A G E N D A

Architectural Review Board

July 25, 2017

Current Canopy:

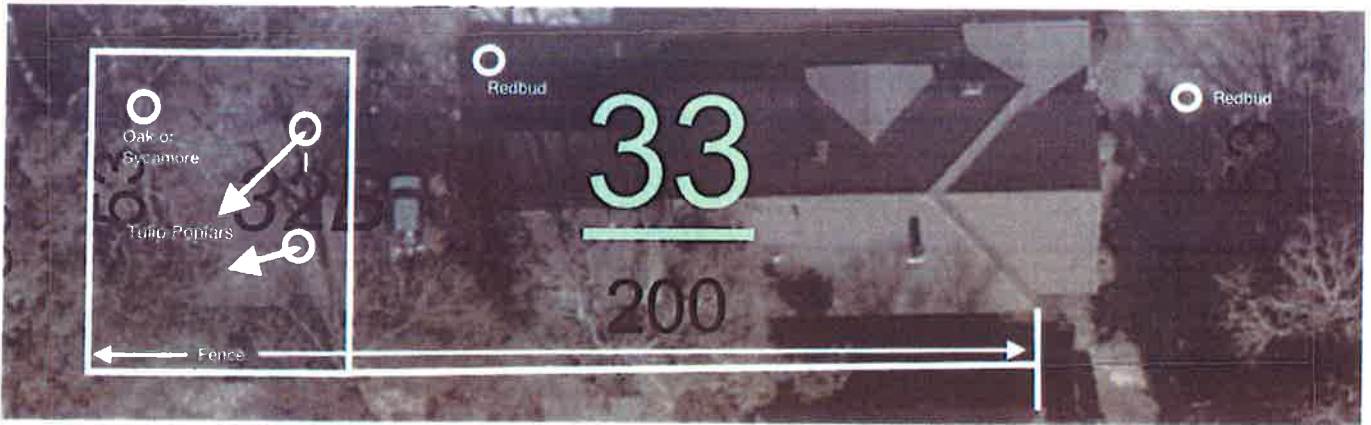
1. Figures 1-4 demonstrate the current canopy on and around the property as well as the proximity of the neighbor's house and fence to the side of our house. (44 S. Capitol Parkway).

(fig. 5 satellite view of property with proposed plantings)

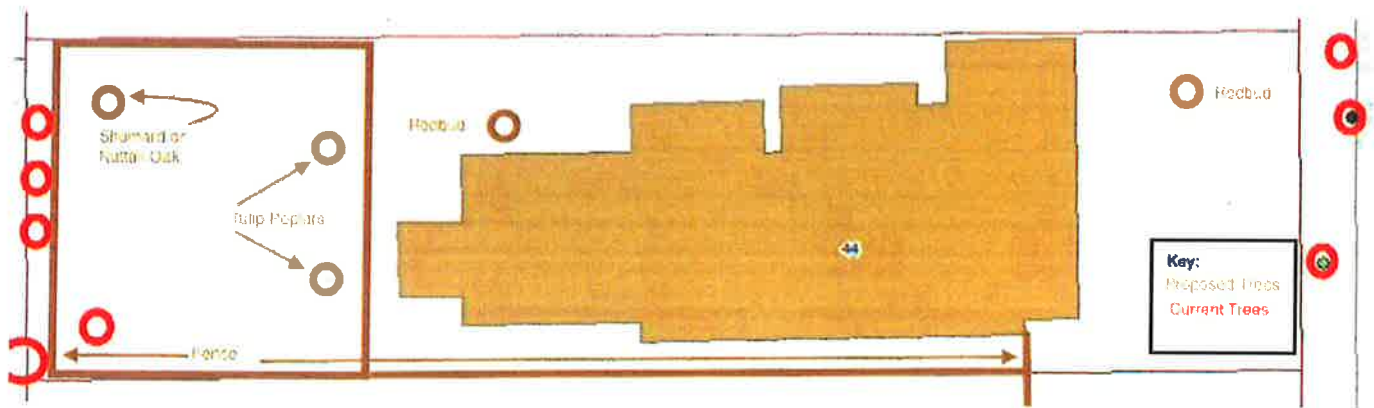
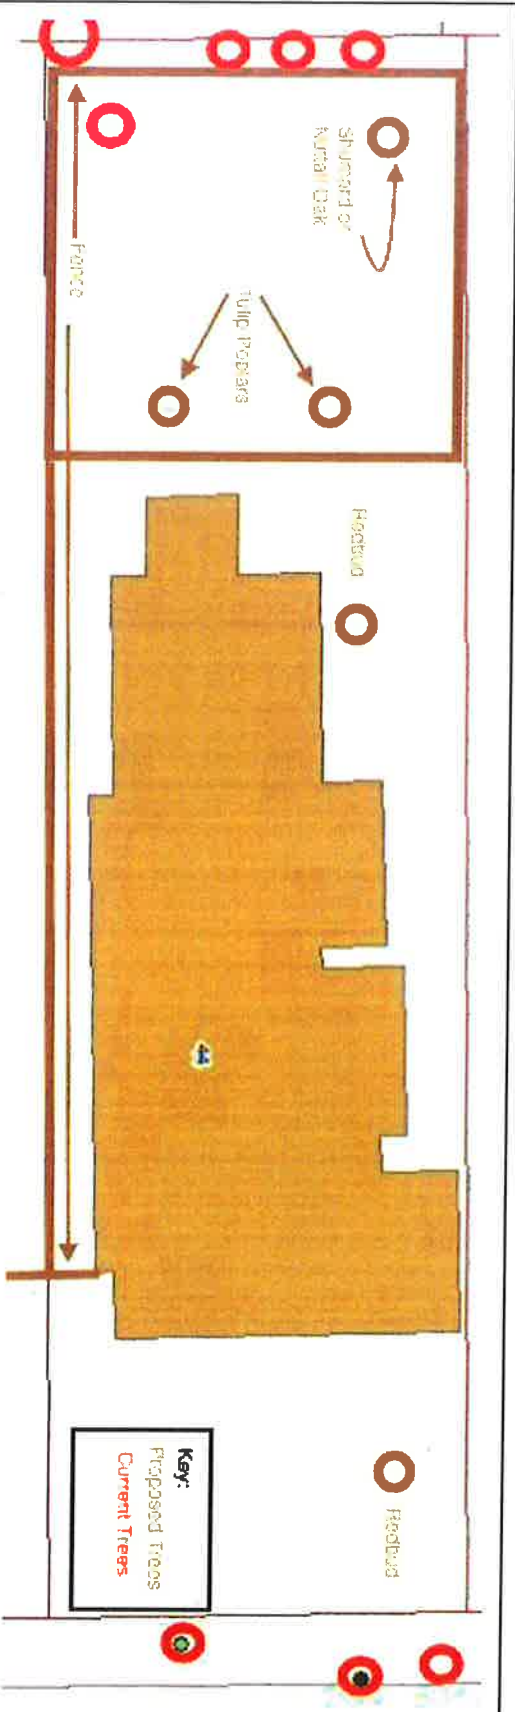
2. Figures 5 & 6 delineate the placement of current trees (in red) and proposed trees (in brown).
 - a. The tulip poplars were chosen to line the parking pad after consultation with Russell Stringer who agrees that the variety would be a good addition to the property for a few reasons:

- b. The Shumard or Nuttall Oak was chosen as a replacement for the Pecan tree after consultation with Russell Stringer. He agrees that either of these trees would be a good replacement as a more "neighborhood friendly" tree than the previous tree. Both of these variety are fast, straight growers that would help mitigate future damage to the fence. (N.B. Figure 5 denotes an oak or sycamore for this tree. Figure 6 was updated to reflect Russell's concern with the problems he has been having with sycamore trees developing a particular blight)

- c. The Redbud trees were chosen as good under canopy trees (proposed by Russell Stringer as opposed to the crape myrtle) that will add to the aesthetic sensibilities of the lot without risking damage to the roof.

622 Felder Avenue

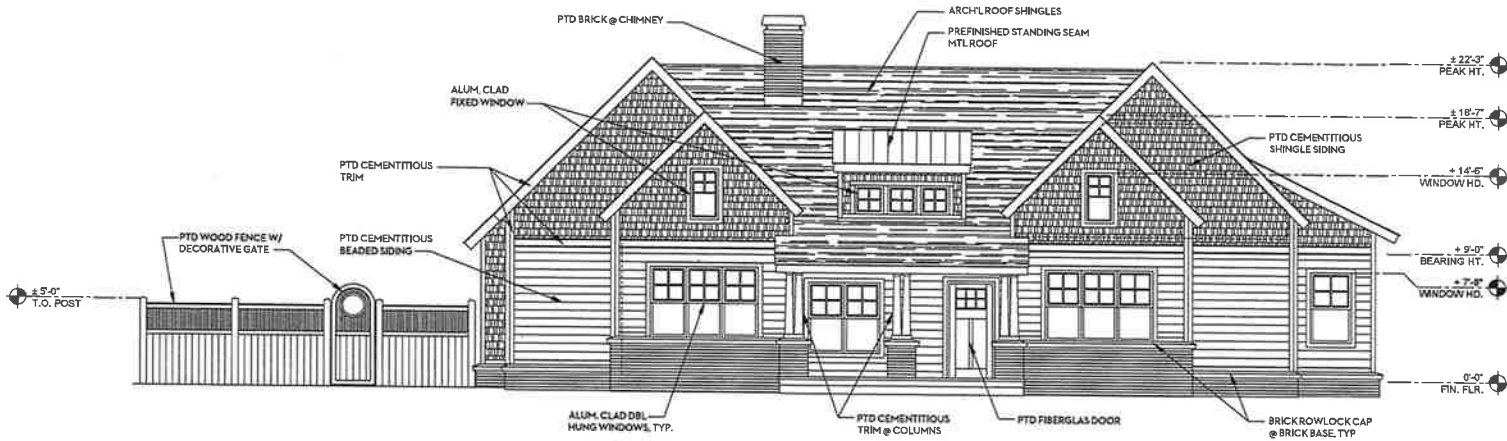
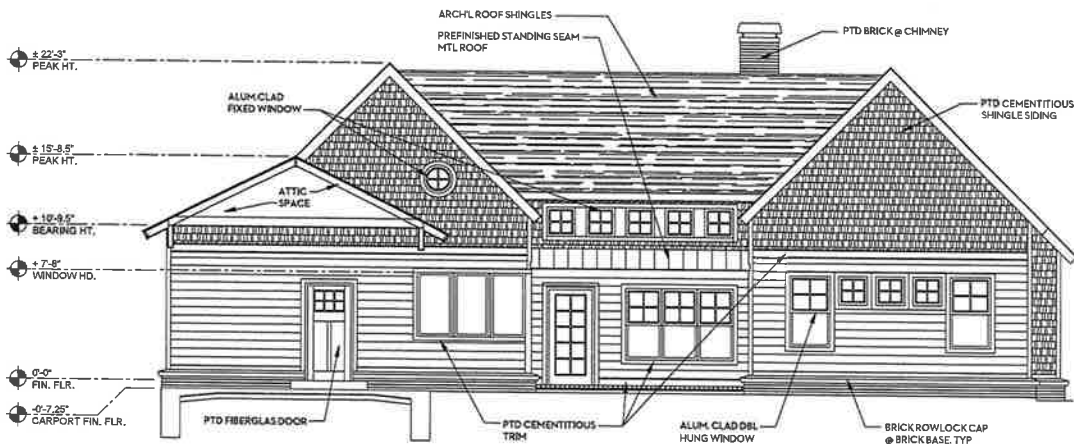
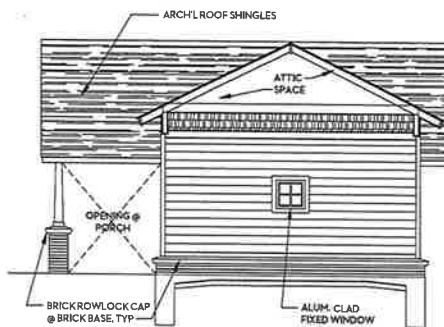
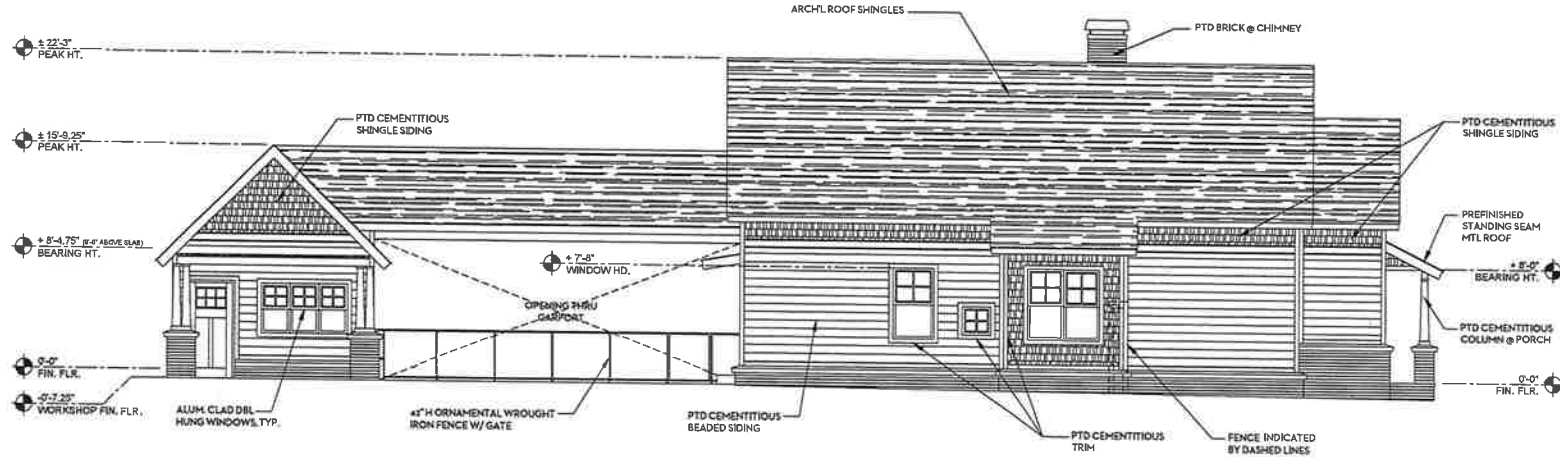
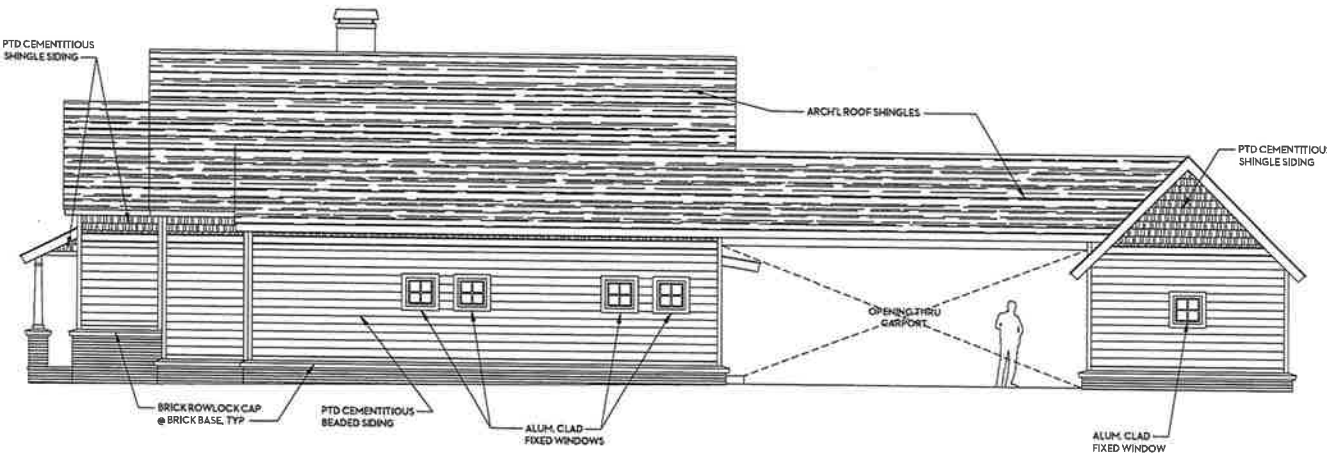
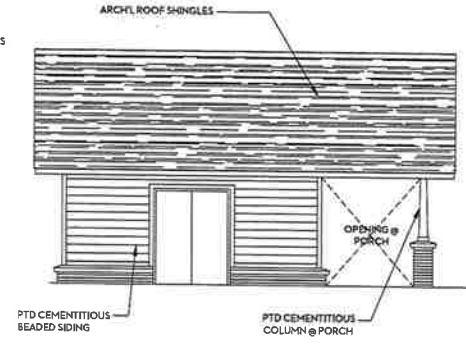
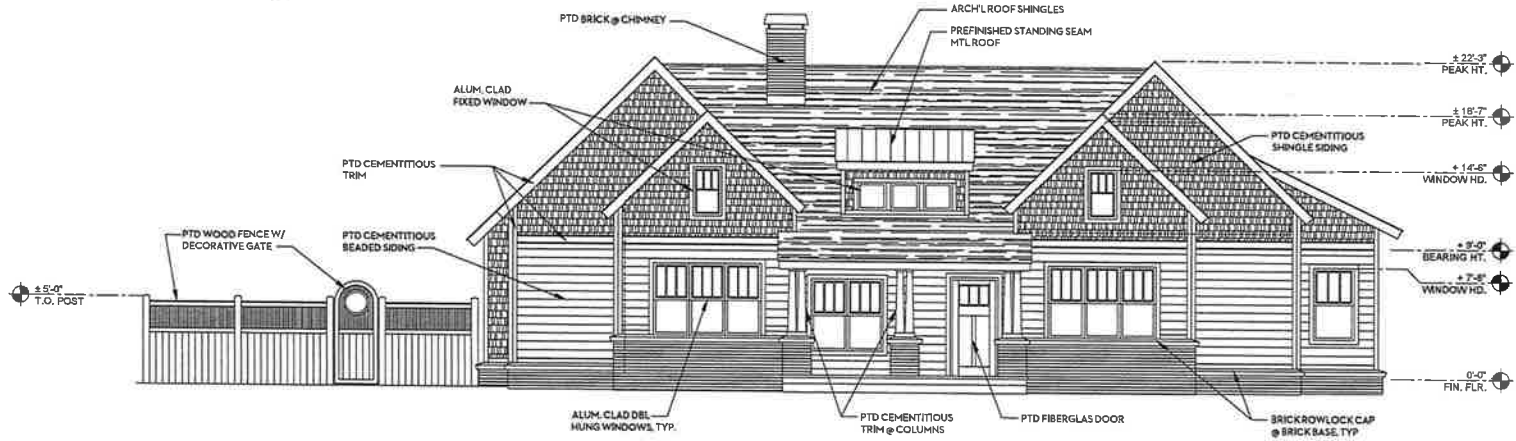
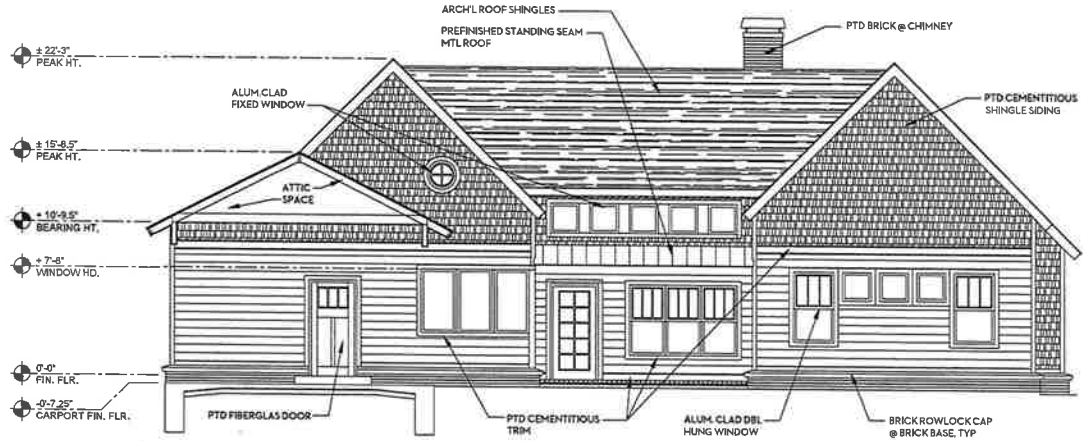
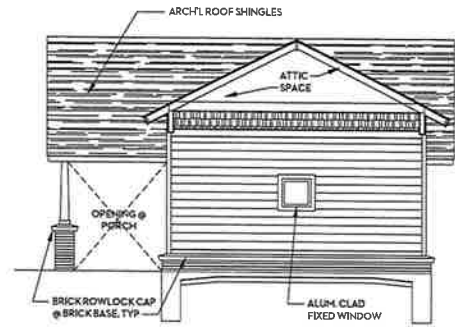
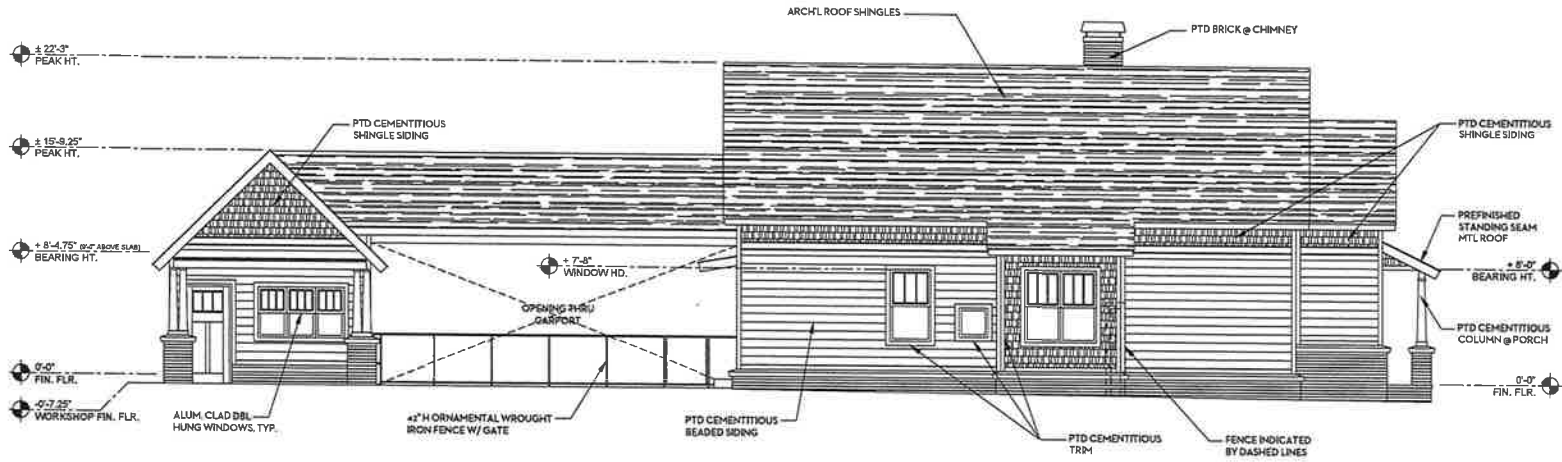
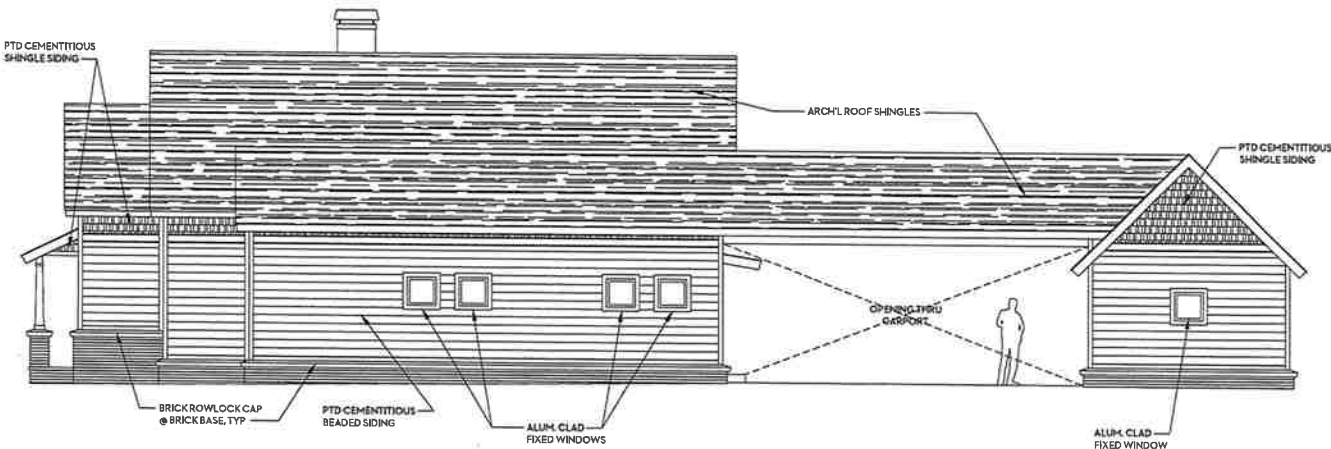
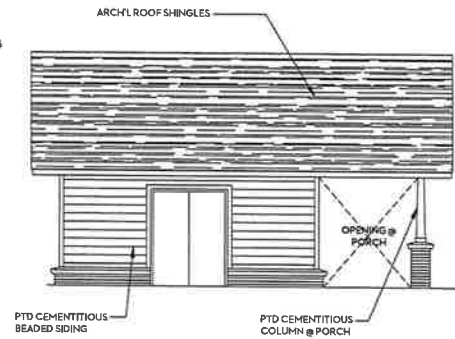
REMARKS: The petitioner is requesting permission to change the 4 lite fixed windows to a single glaze, and the 4:1 sash windows to a vertical lite 3:1 configuration as illustrated.

- The vertical lite windows are a Craftsman configuration and this is a nouveau Craftsman design.
